COVER SHEET
C0.0
1 of 53 Sheets

EAST TOWN CROSSING PHASE 1

GRADING PLAN NE

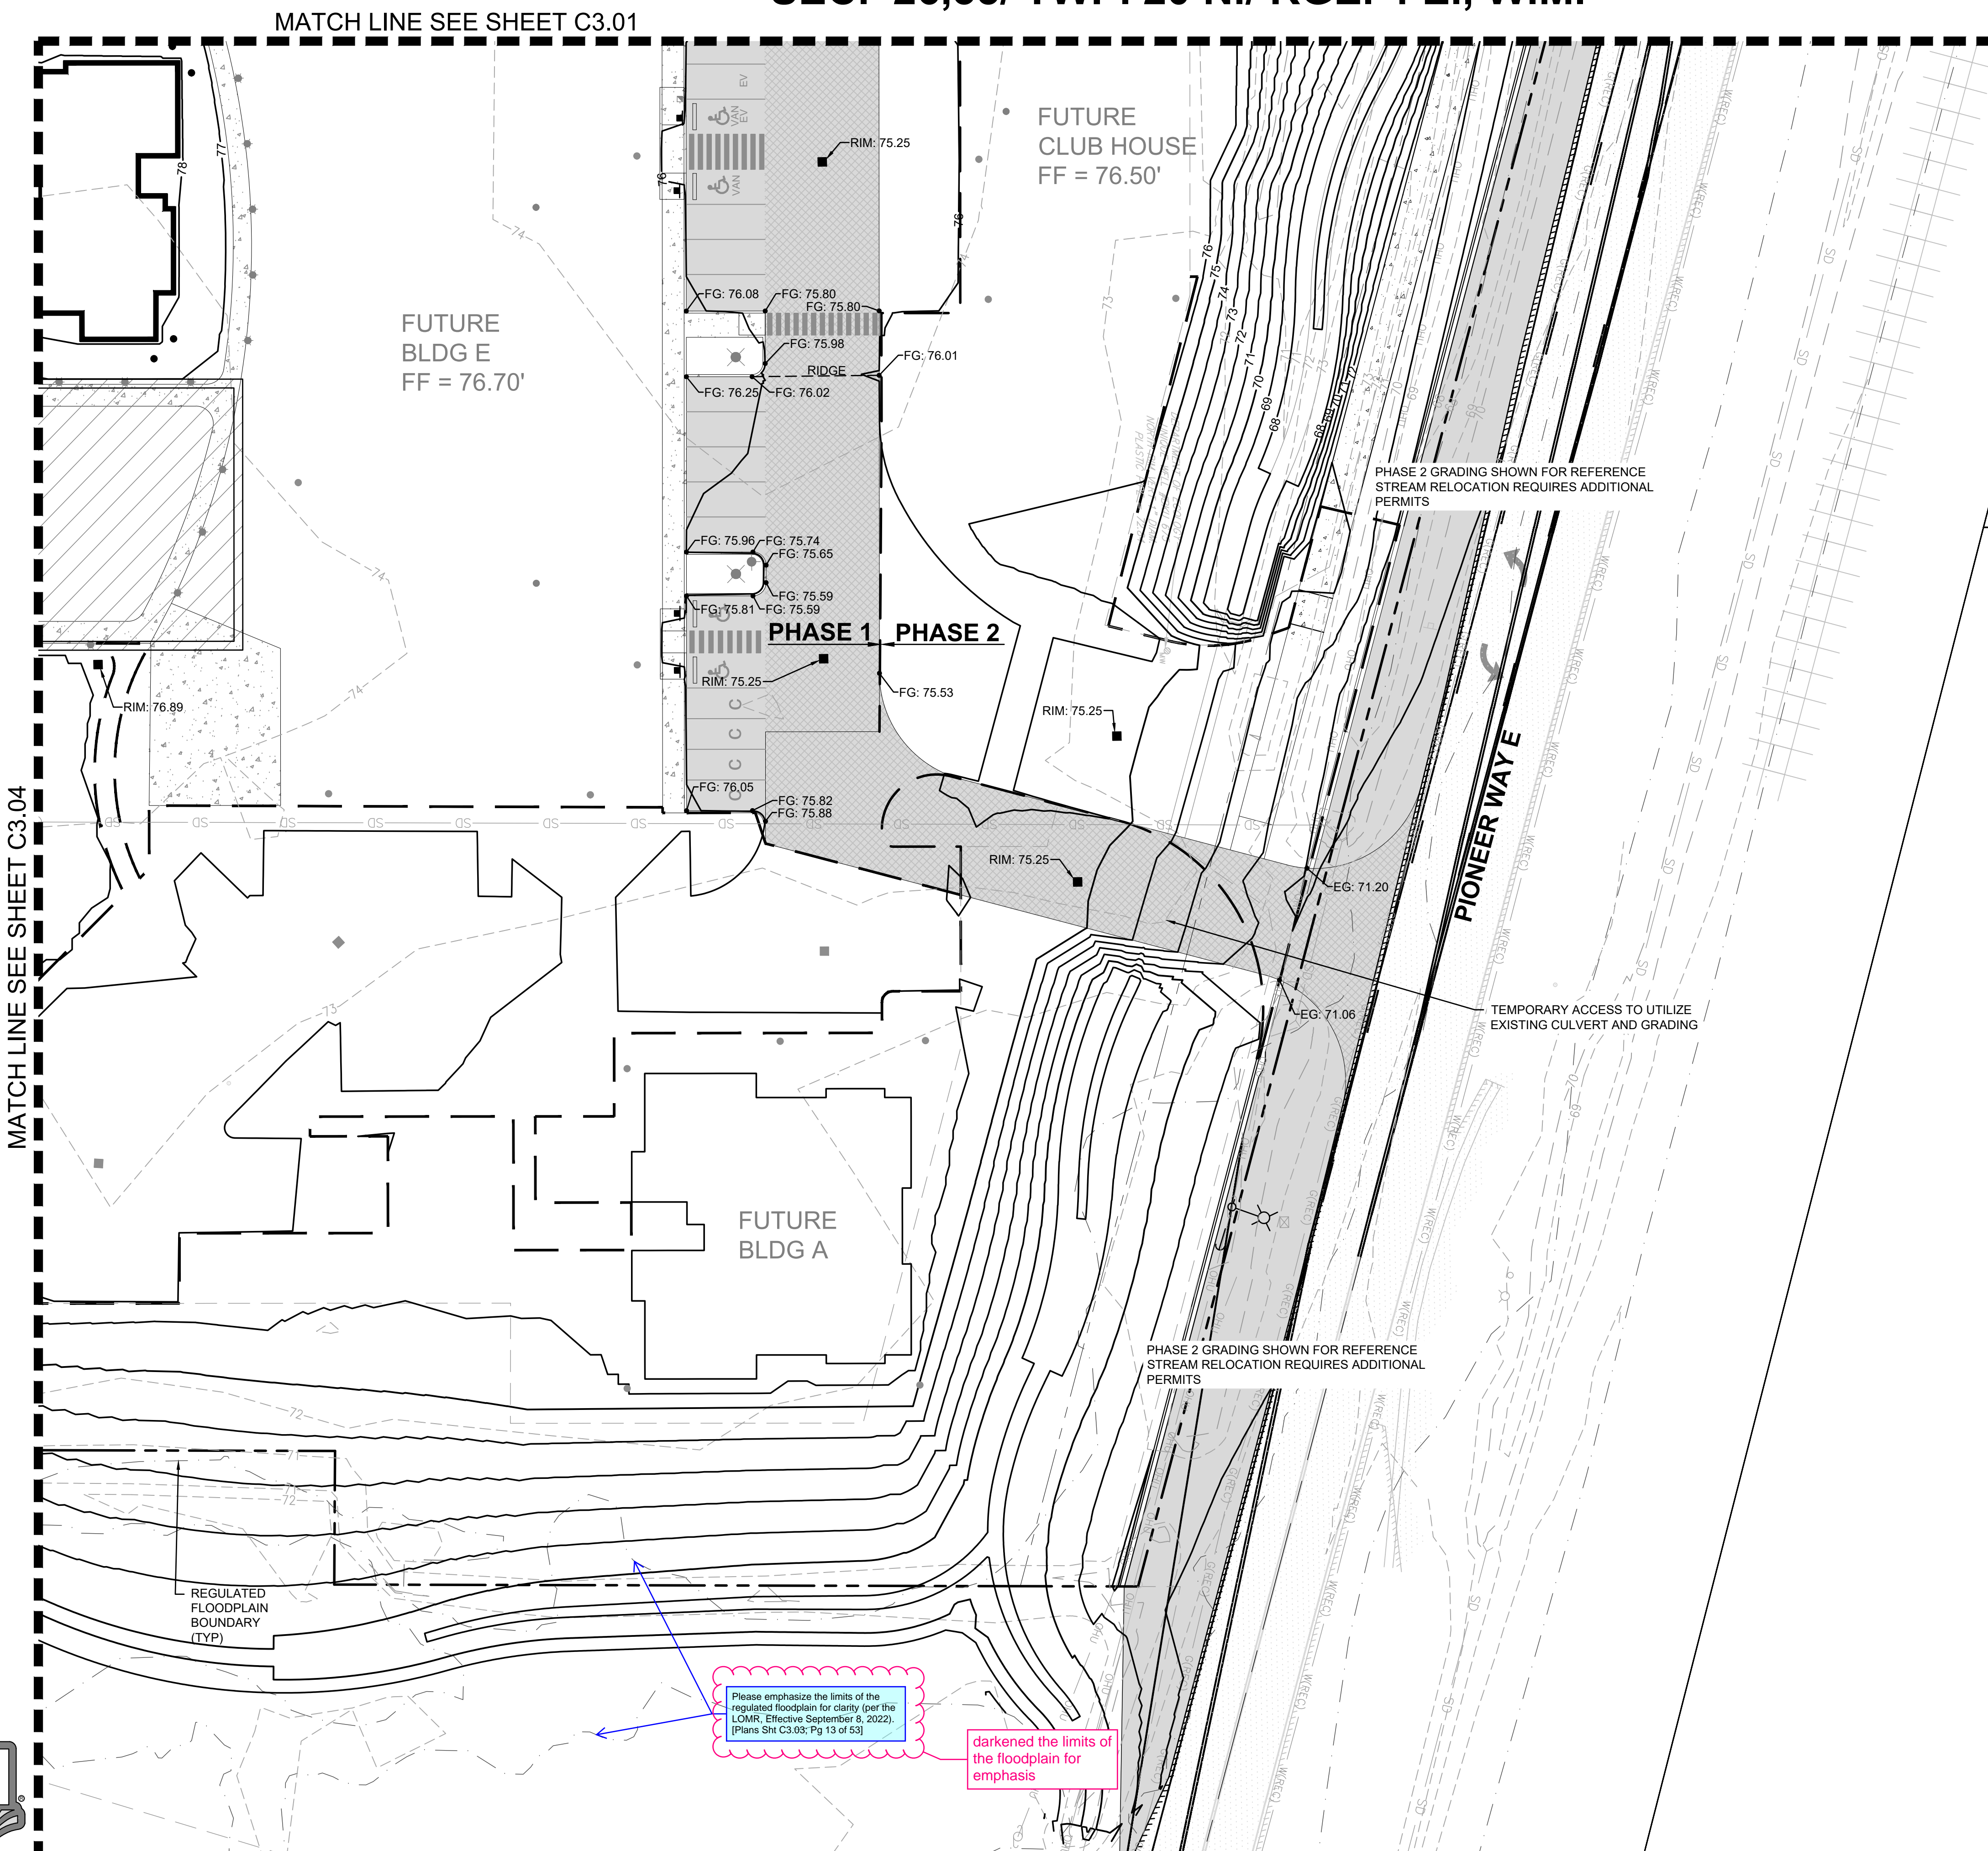
Please emphasize the limits of the regulated floodplain for clarity per the LOMR, Effective September 8, 2022. (Plans Sht C3.03; Pg 13 of 53)

Revise to C3.03

Sheet Title:
GRADING PLAN SE

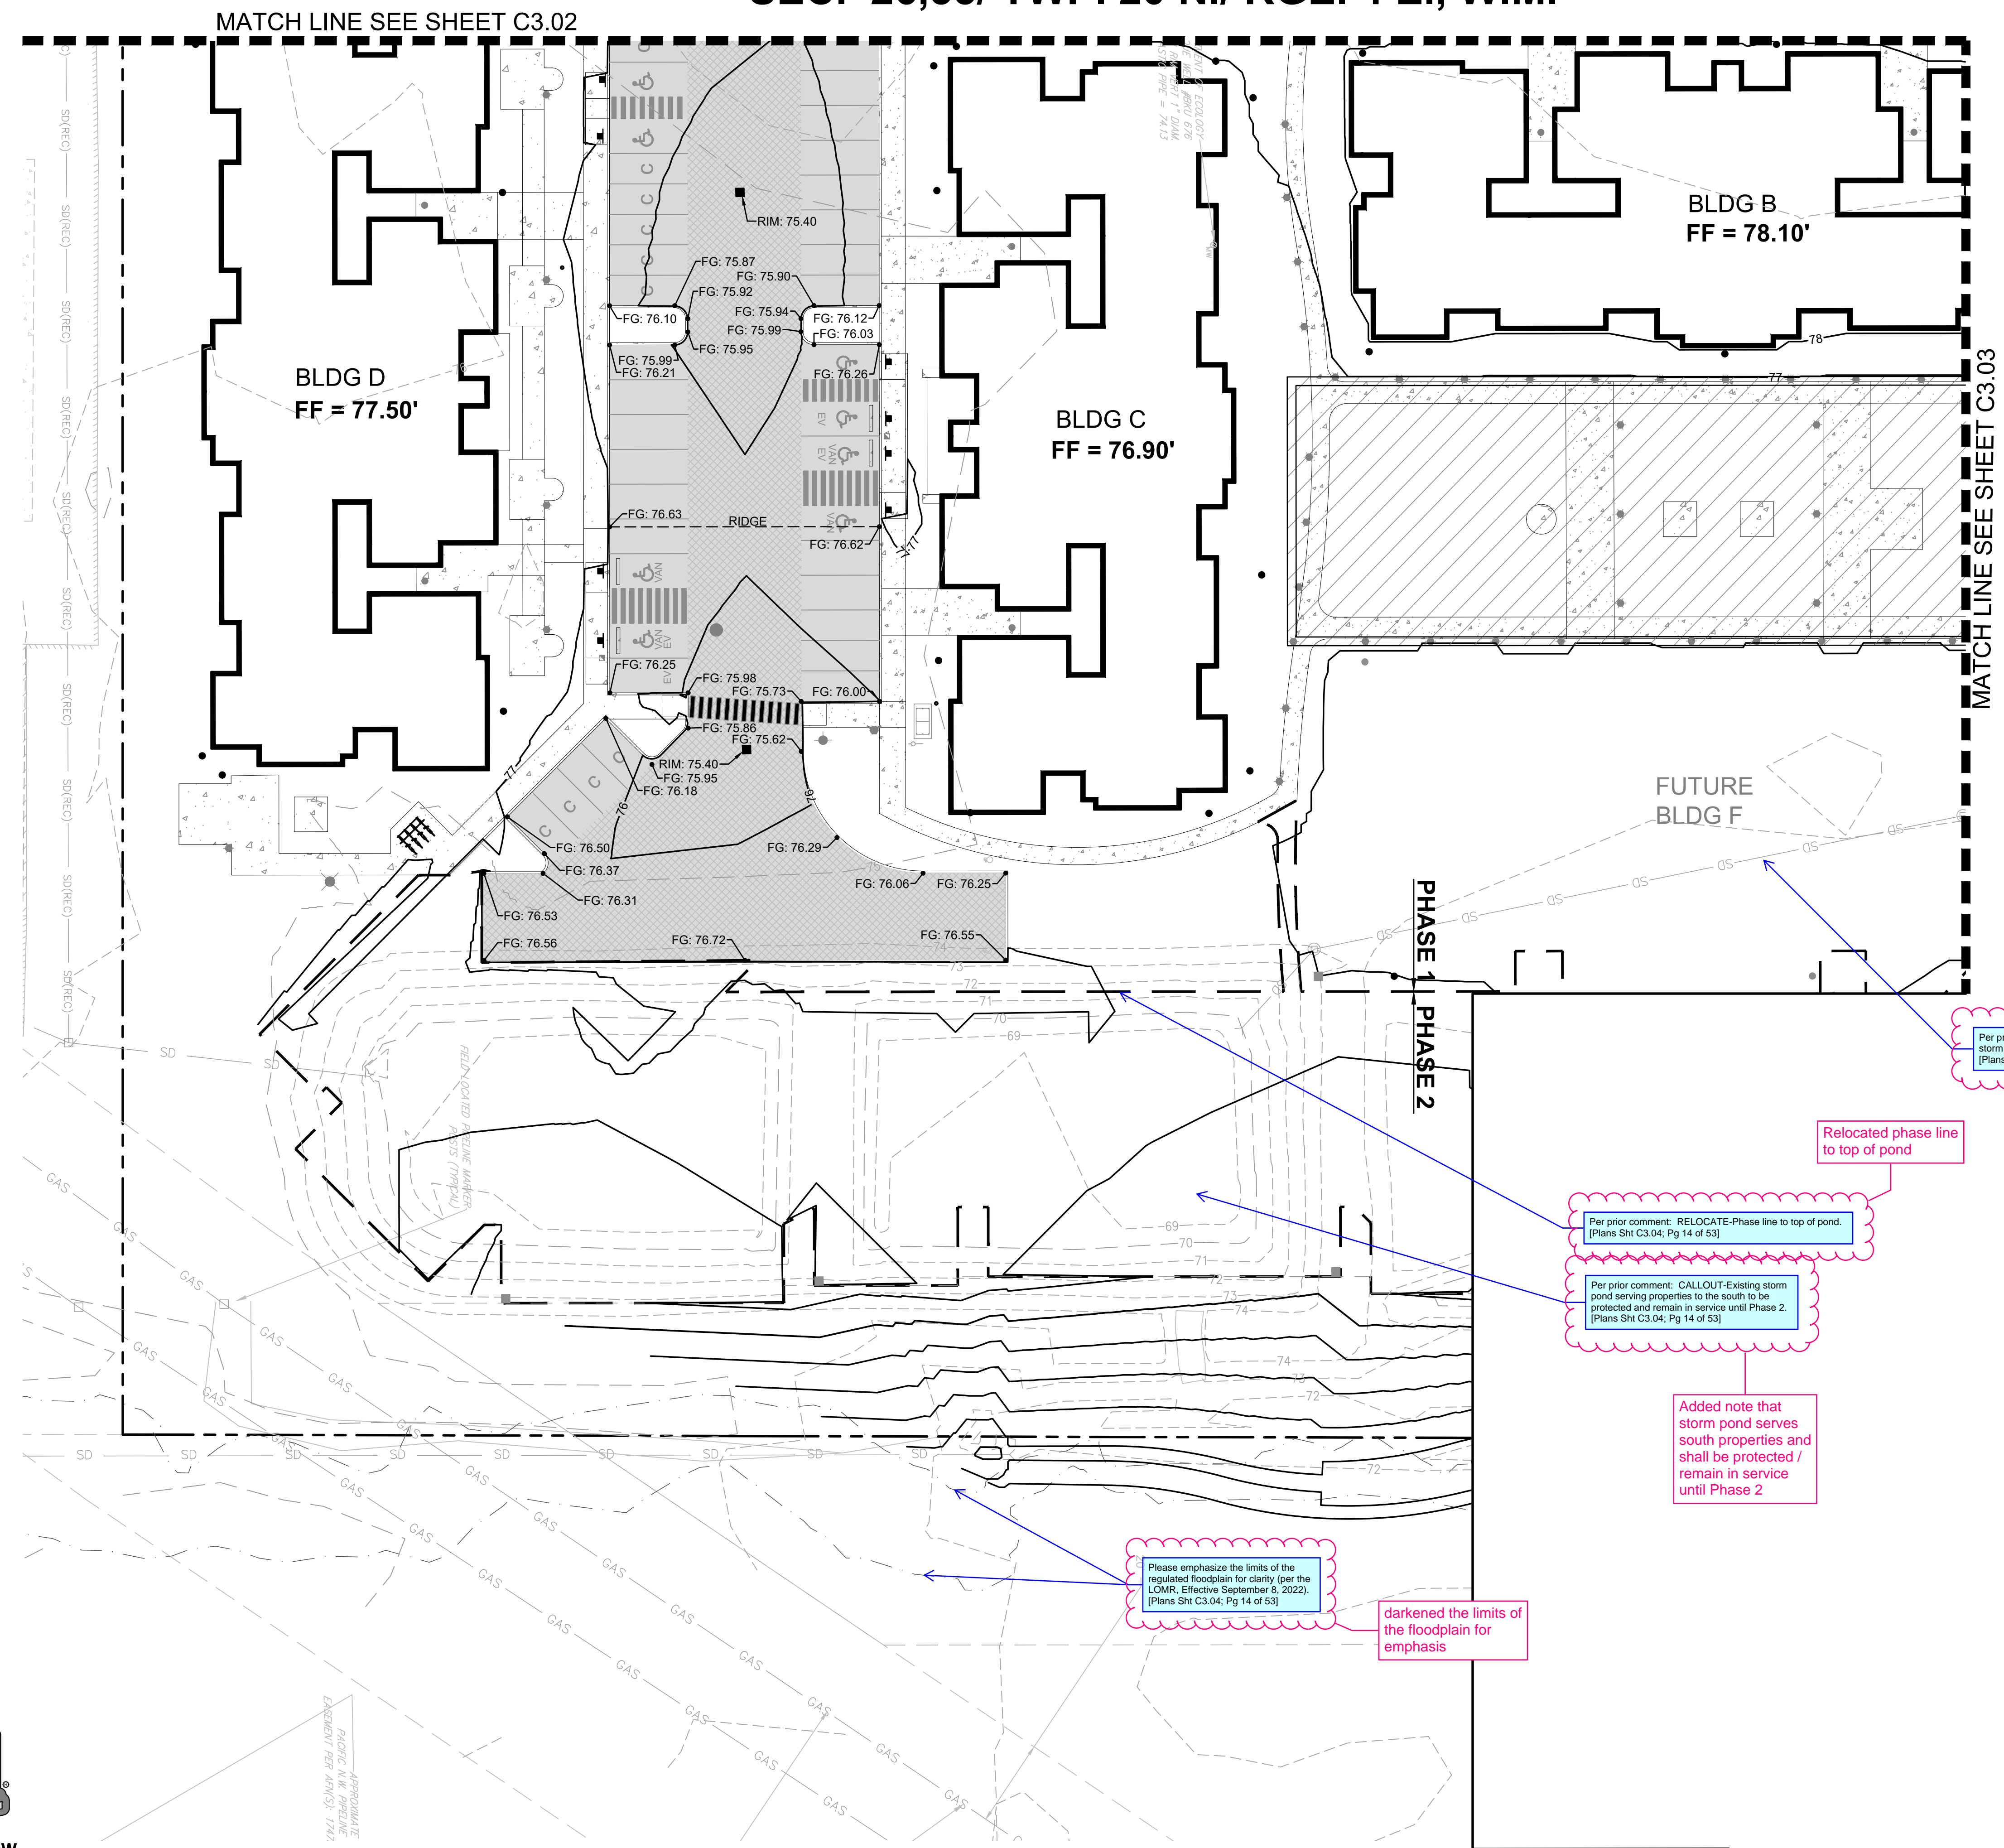
Per prior comment: CALLOUT-to protect existing storm drain serving properties to the south. [Plans Sht C3.04; Pg 14 of 53]

Per prior comment: RELOCATE-Phase line to top of pond. [Plans Sht C3.04; Pg 14 of 53]

Per prior comment: CALLOUT-Existing storm pond serving properties to the south to be protected and remain in service until Phase 2. [Plans Sht C3.04; Pg 14 of 53]

Please emphasize the limits of the regulated floodplain for clarity (per the LOMR, Effective September 8, 2022). [Plans Sht C3.04; Pg 14 of 53]

Added note that storm pond serves south properties and shall be protected / remain in service until Phase 2

Added note to protect existing pipe

Sheet Title:
STORM DRAINAGE PLAN SW

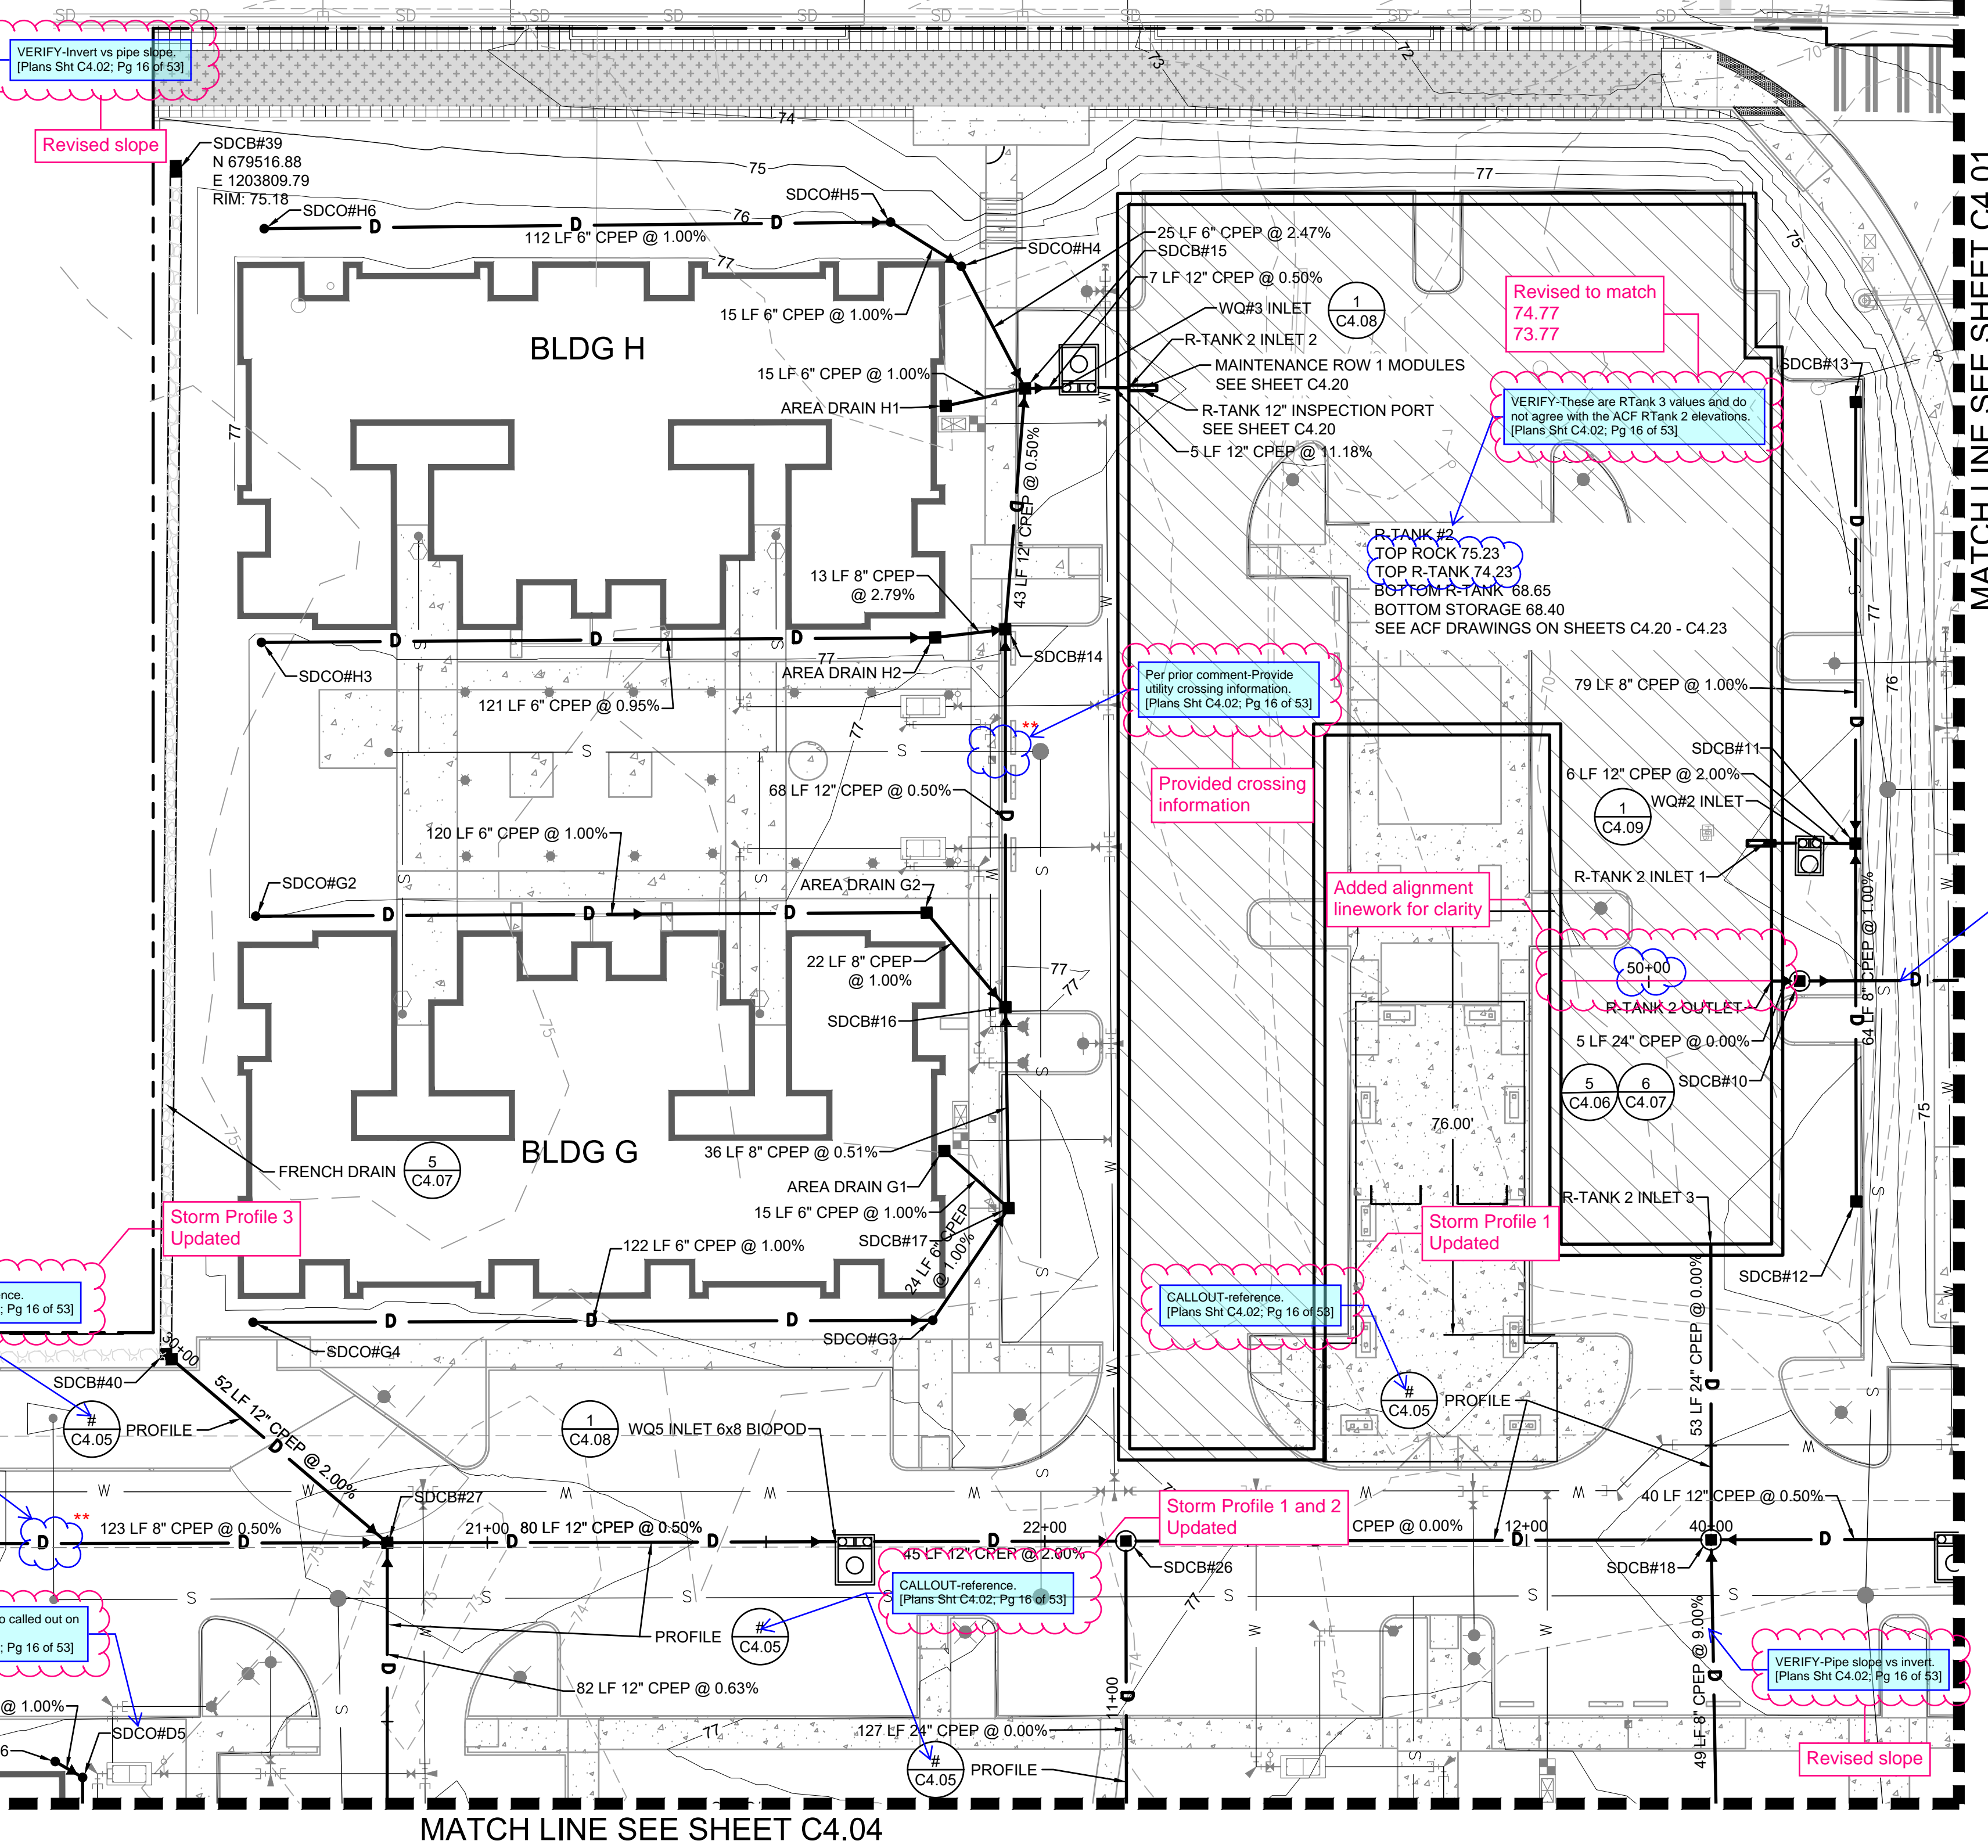
VERIFY-Is it necessary to have such a large pipe into and out of the control structure? [Plans Sht C4.02; Pg 16 of 53]

Large pipe is for overflow events (storms above those designed for) to allow water to leave the system without damaging the R-Tanks
